Subject OPOG Responses to EPA 2-8-06 MIP/SVS Comments

Responses to EPA Comments Dated February 8, 2006
On-Site Soils RI/FS Work Plan Addendum No. 2
Summary of Initial Findings from Soil Vapor and MIP Sampling
(CDM, January 27, 2006)

Figure 9. Freon 113 (mg/m³) 40 - 59 feet bgs

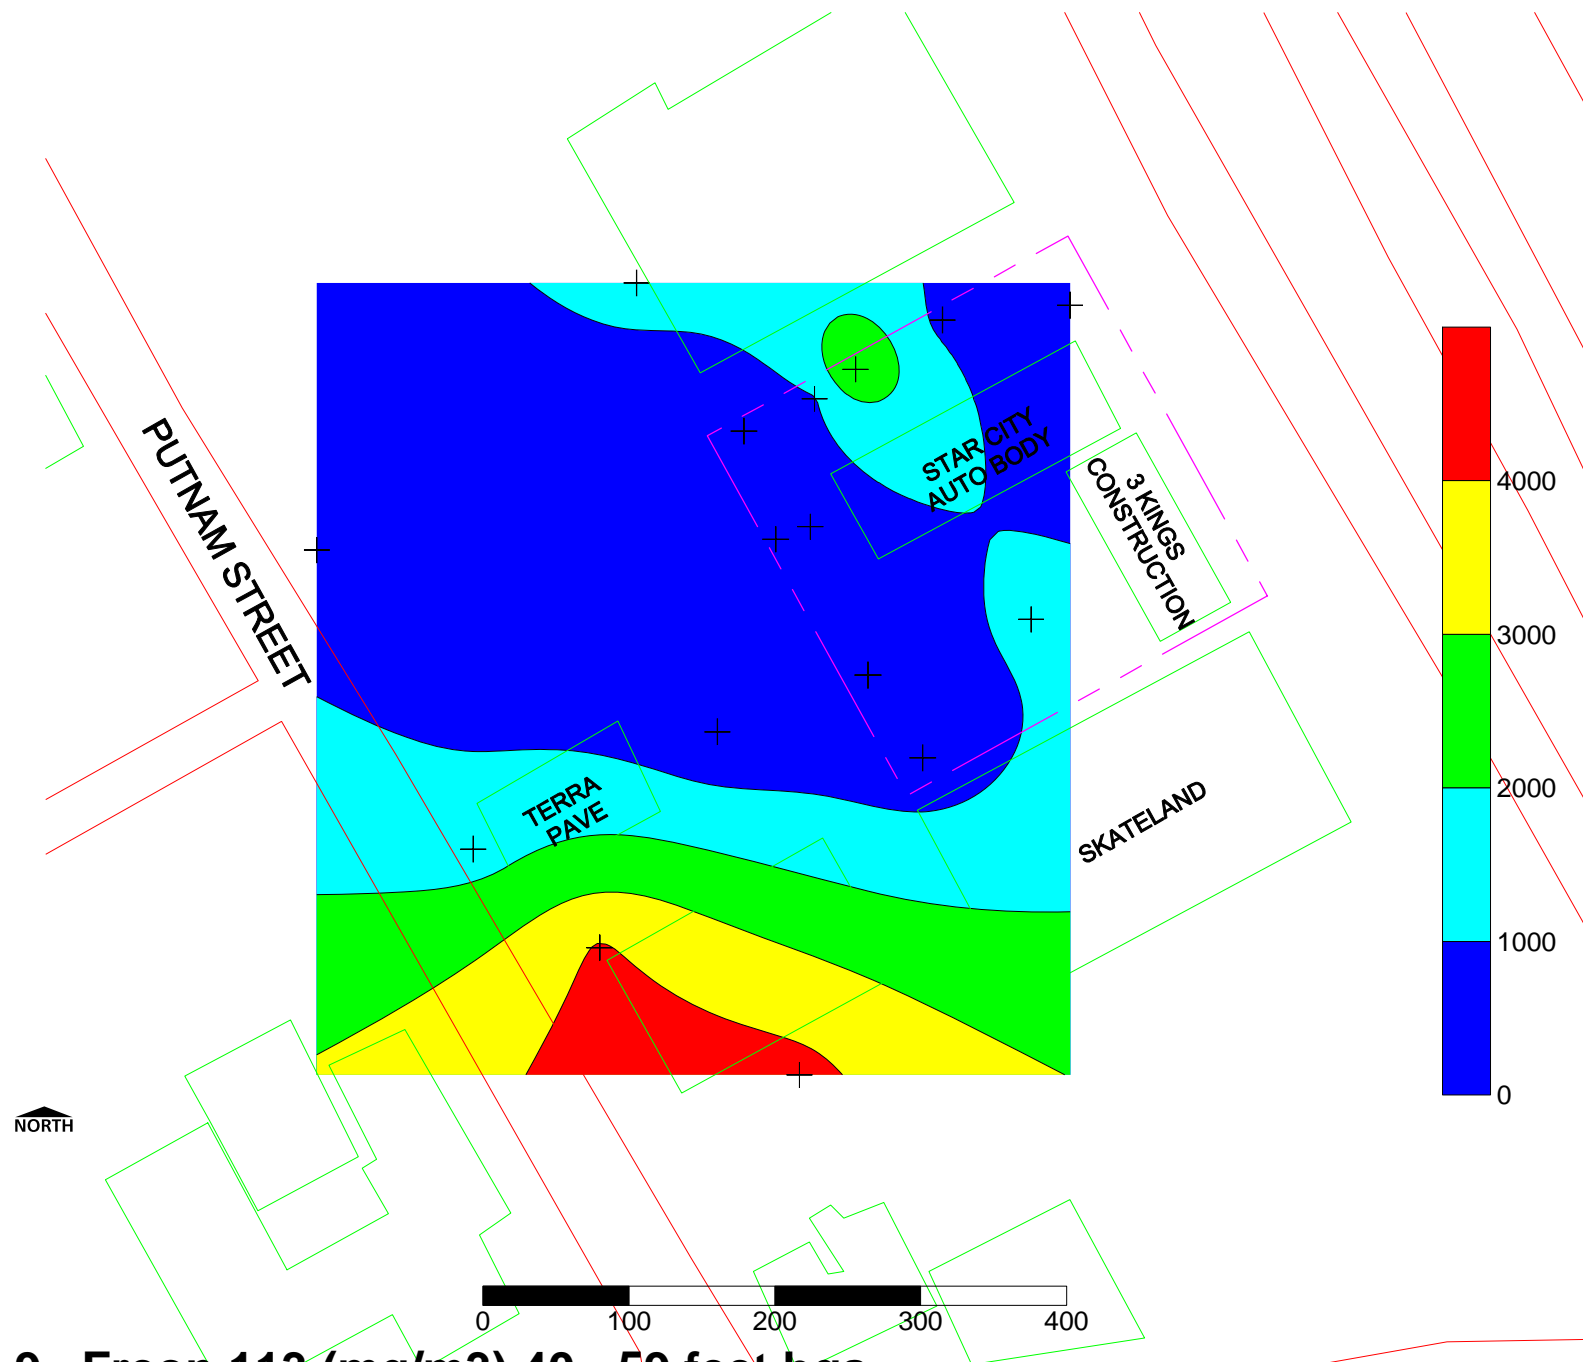
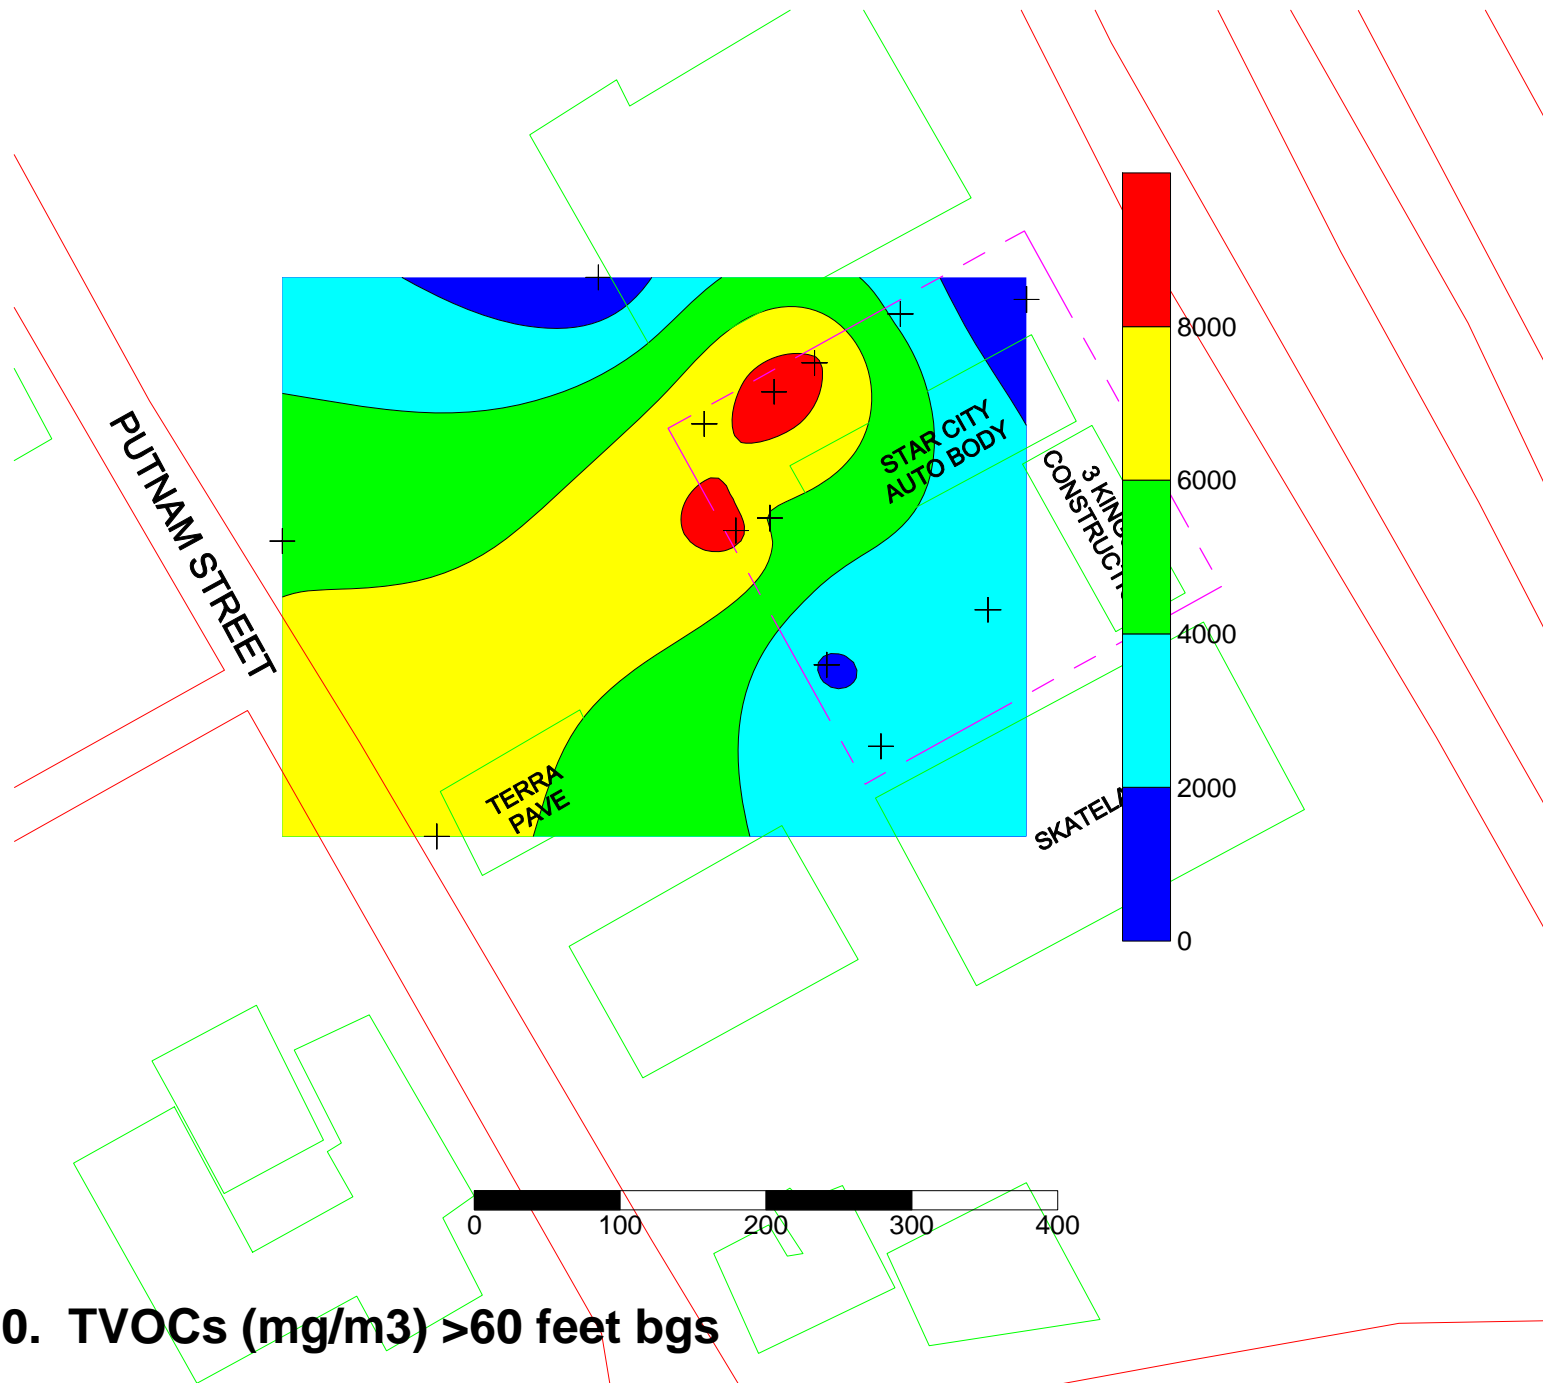
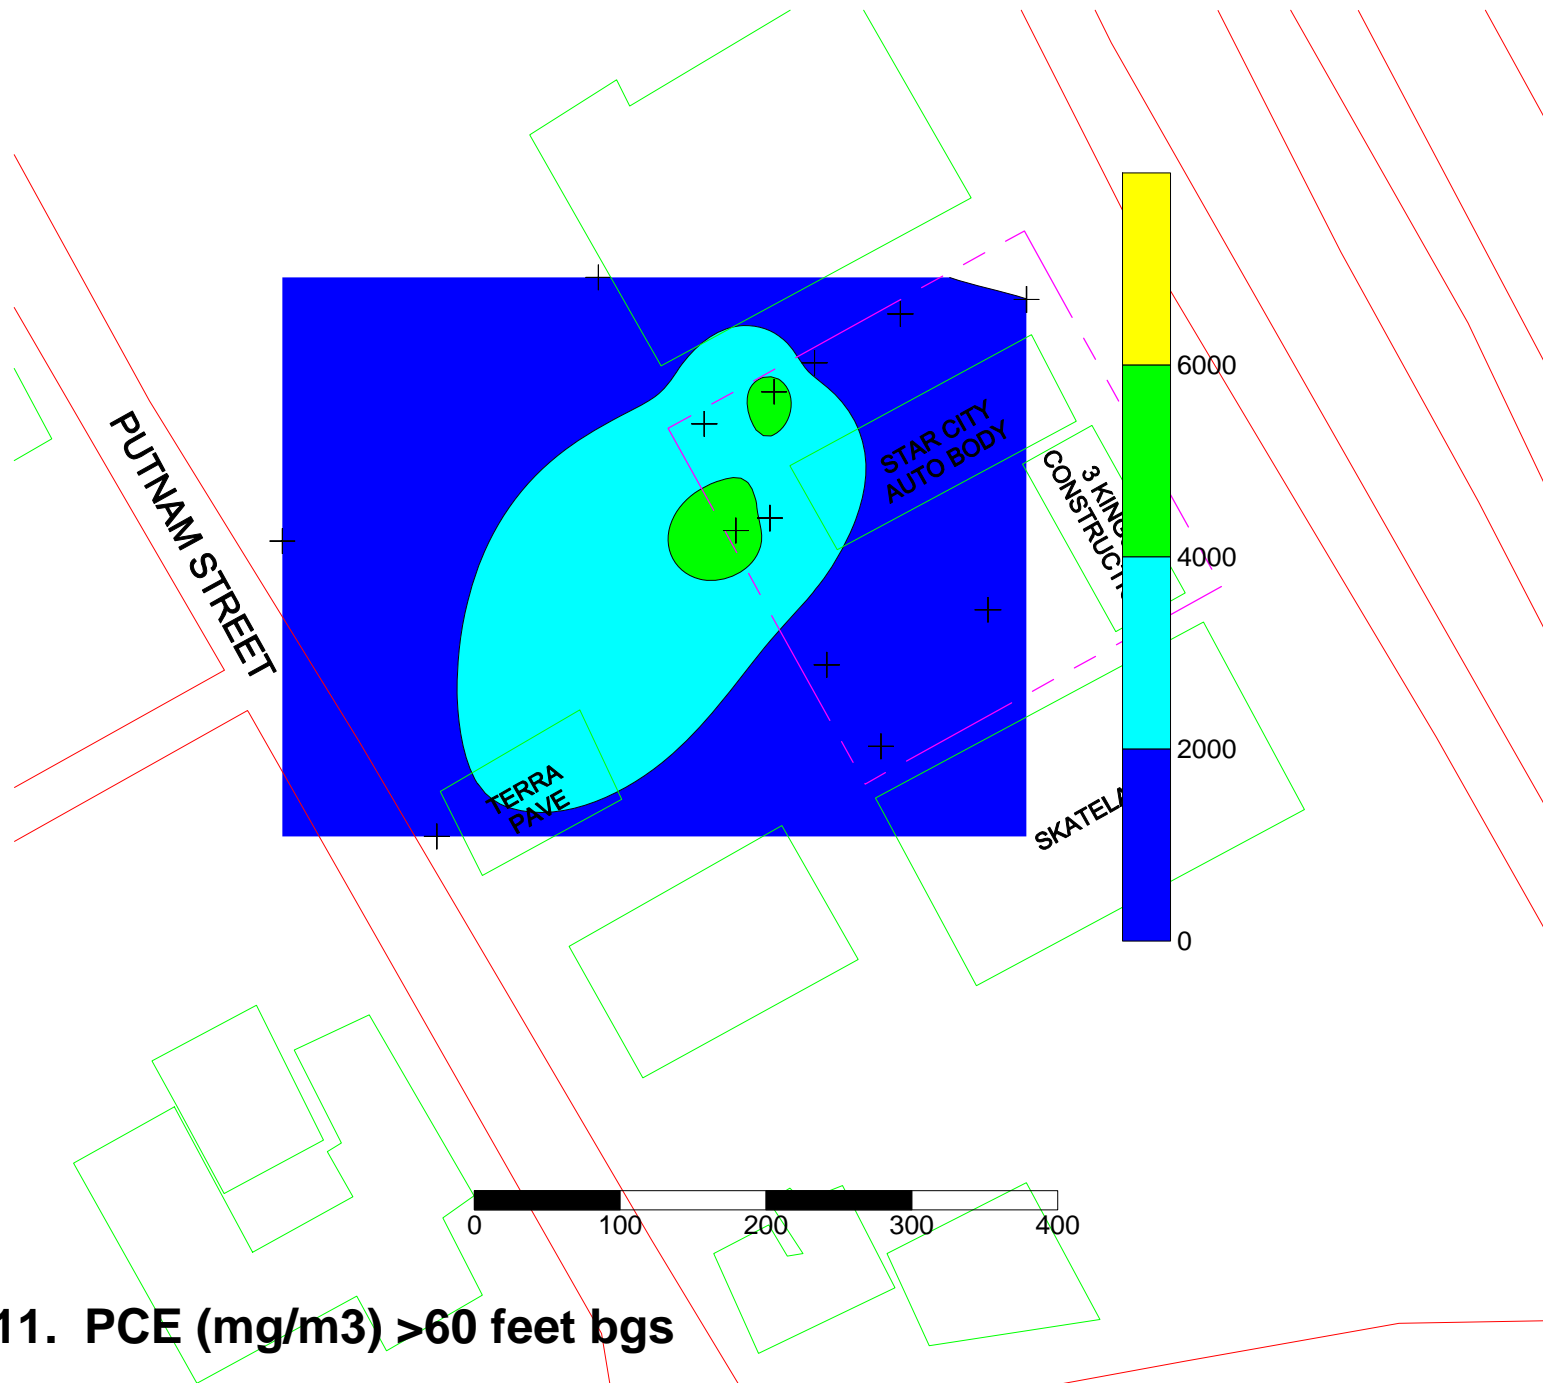
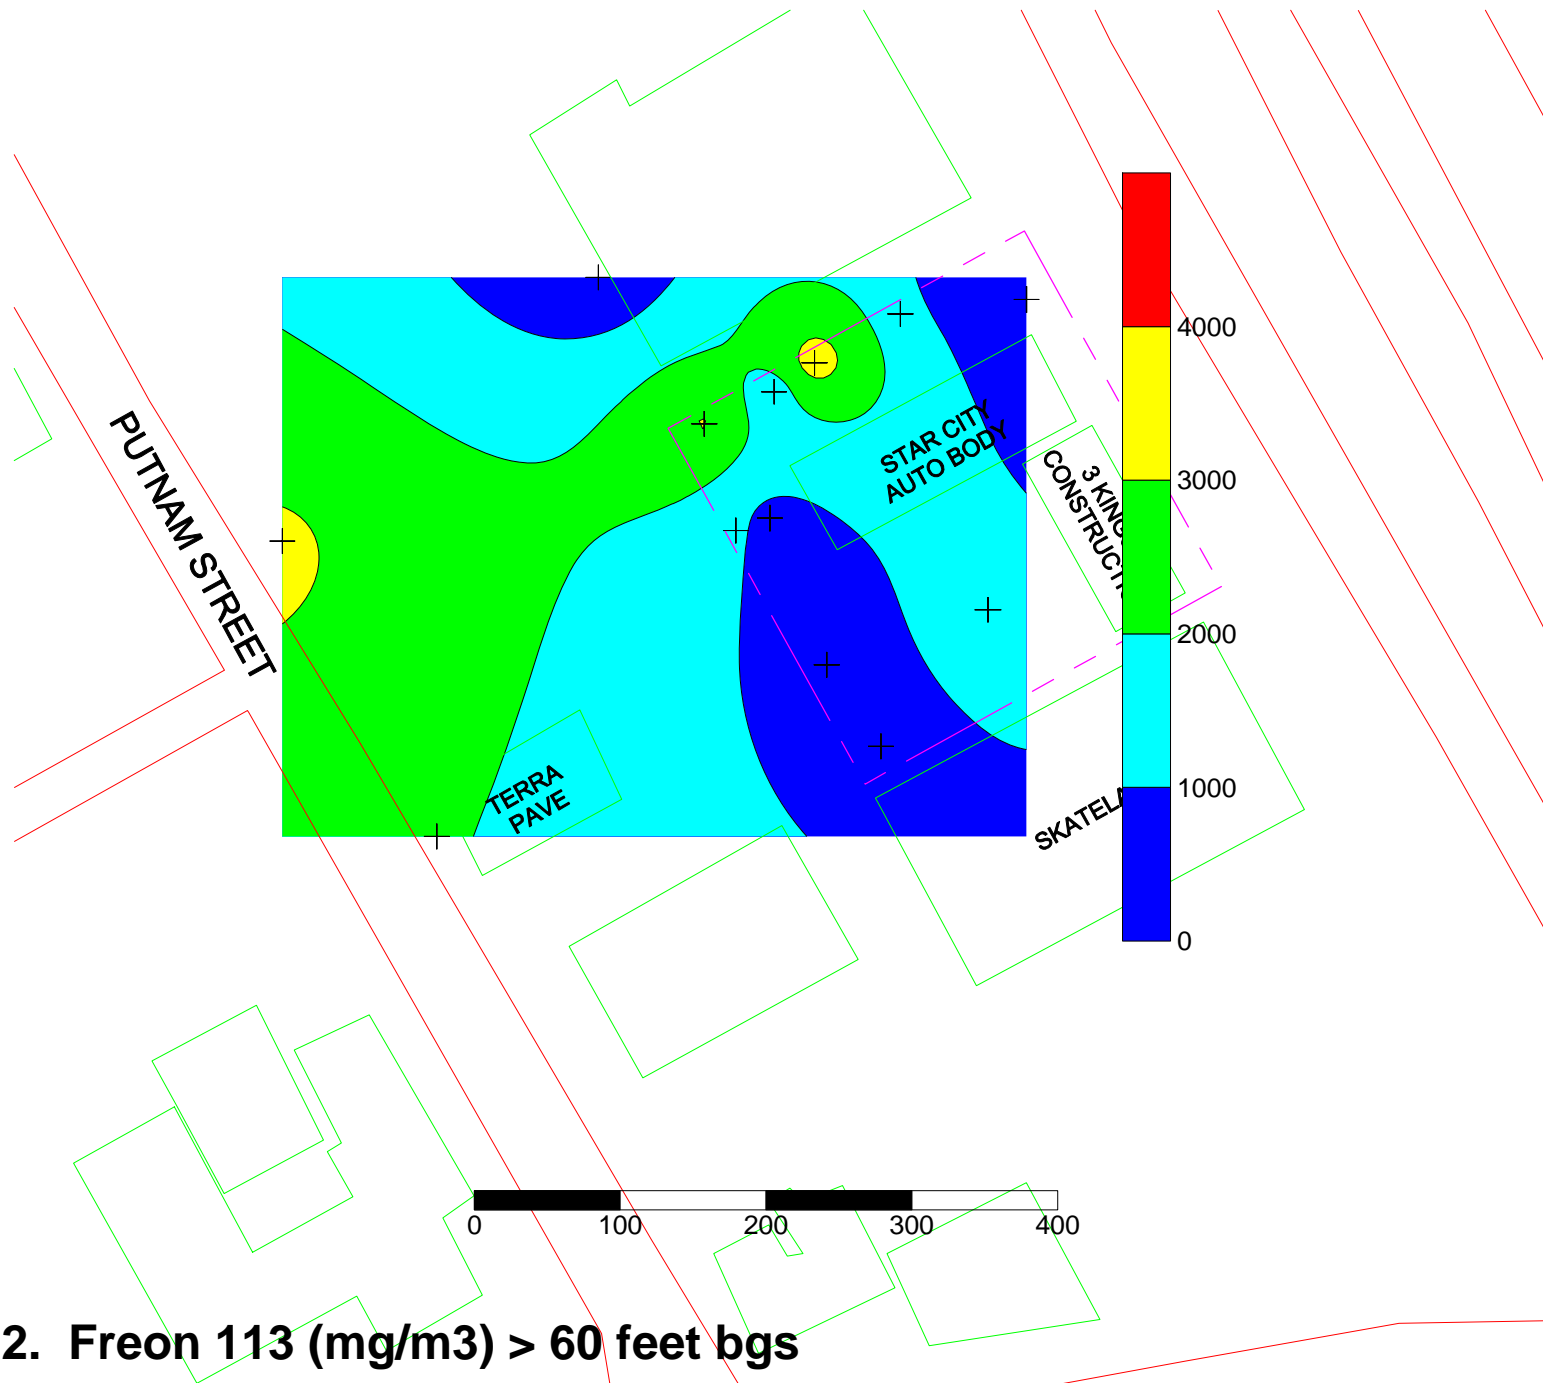
8. Prepare contour maps for total VOCs, PCE, and Freon 113 (plus any other compounds that OPOG/CDM selects) in addition to the pie chart maps (Figures 19 to 22). The contours will indicate potential source areas as well as locations where additional sampling is needed.

Response: Contour maps have been prepared and are provided in the attached PowerPoint file.
